DATE: March 13, 2026
TO: ALL CONTRACTORS
FROM: DUSTIN TILL
PROJECT: ROSCOE ROAD WATER TREATMENT PLANT
ORANGE BEACH WATER AUTHORITY
GMC PROJECT NO. CMOB230049
RE: ADDENDUM #5

ADDENDUM NUMBER 5

ROSCOE ROAD WATER TREATMENT PLANT

GMC PROJECT NO. CMOB230049

E TYPICAL PIPE SUPPORT PLAN
S-003 SCALE: 3/4" = 1'-0"

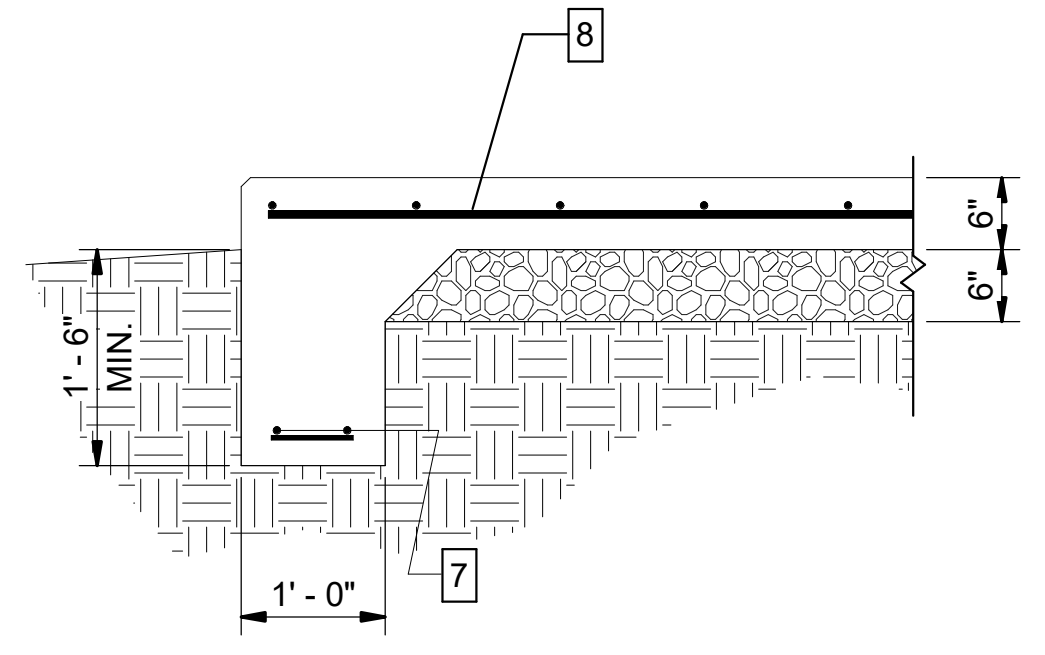
Answer: Type II Portland Limestone Cement is acceptable as long as it meets the required strength and design criteria.
- 5.37 **Question: Plan Sheet S-201, Key Note #1 references concrete pipe supports, however no rebar details are provided. Please provide a concrete pipe support detail.**

Answer: A concrete pipe support detail has been added to S-003 and is included as an attachment to this addendum.
- 5.38 **Question: Does Detail K/C-912, Casing and Carrier Pipe Under Paved Roads detail, found on drawing sheet C-912, apply anywhere on the project? I have not noticed it called out anywhere on the drawings. If it does, please state where and on what lines**

FILTRATION HEAD BOX - PLAN & SECTION

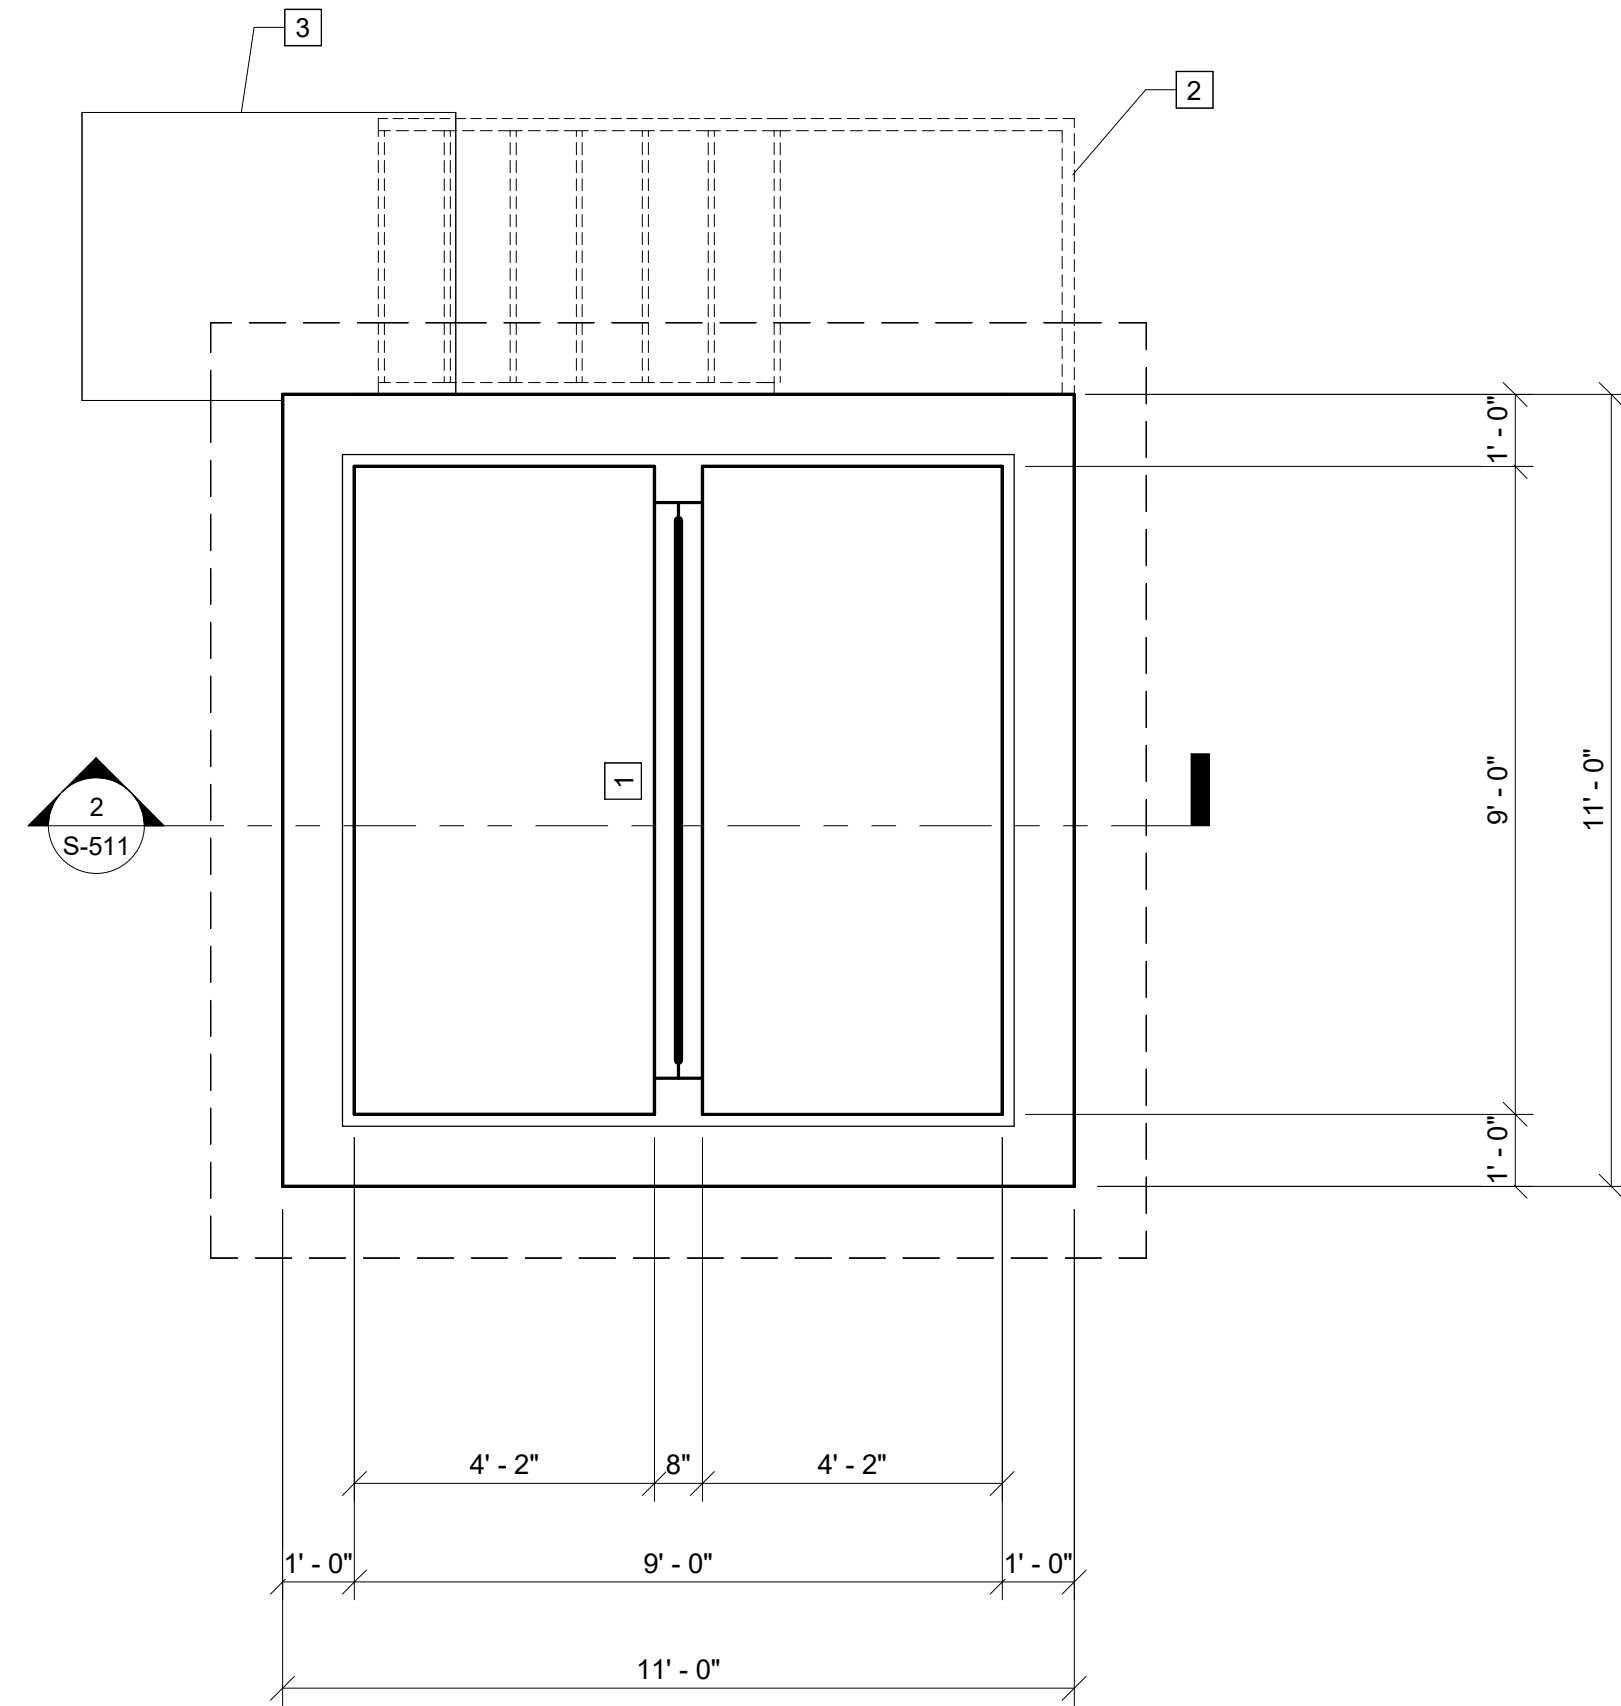
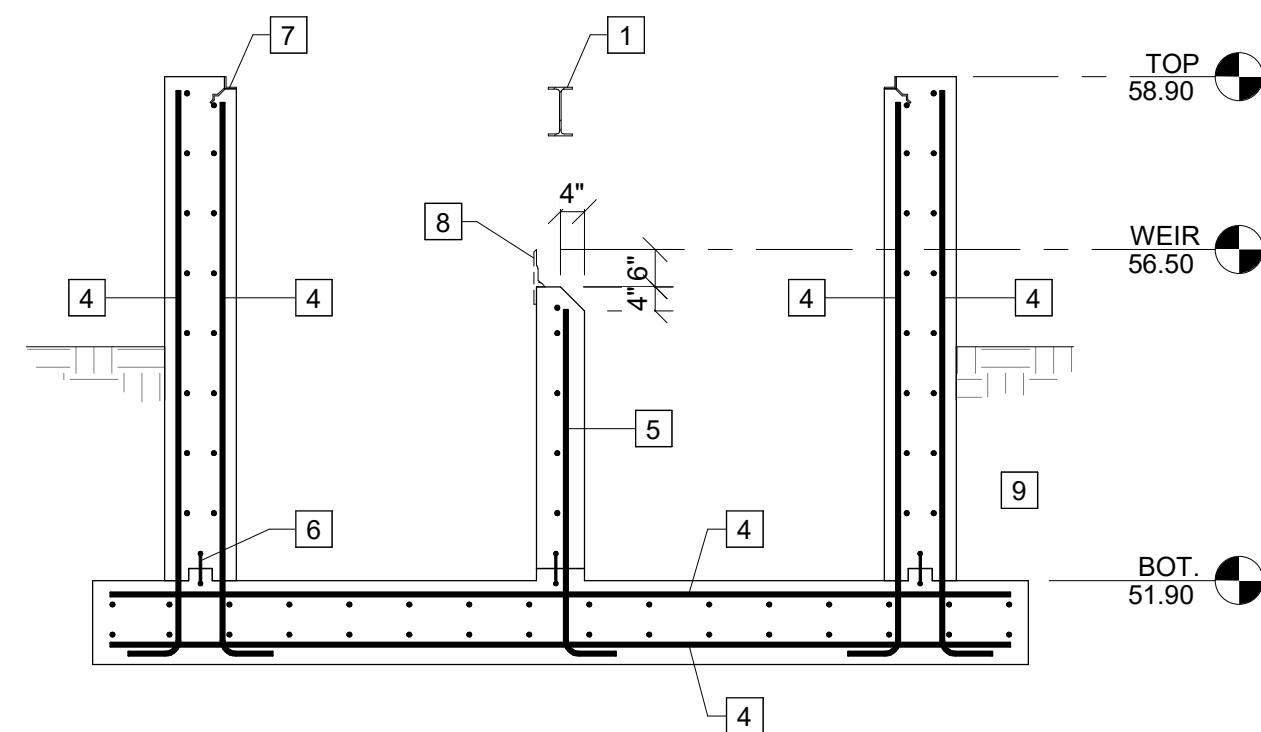
- 5.1 **Question: The Filtration Head Box is shown on sheets A-511, D-511 and on the Civil Drawings. Is this structure cast-in-place or precast? Please provide dimensions and details for the structure as well as wall and slab thicknesses, reinforcing, etc.**

Answer: Sheet S-511 has been added for the Filtration Head Box and is included as an attachment to this addendum.
- 5.2 **Question: Referencing plan sheet S-501. Where section C cuts through the left side there is a spread footing shown in plan and section. Should there be one on the right side of the filters? It seems to be the same condition however we cannot find a cut through this area so we really do not know what is happening here. Please clarify.**
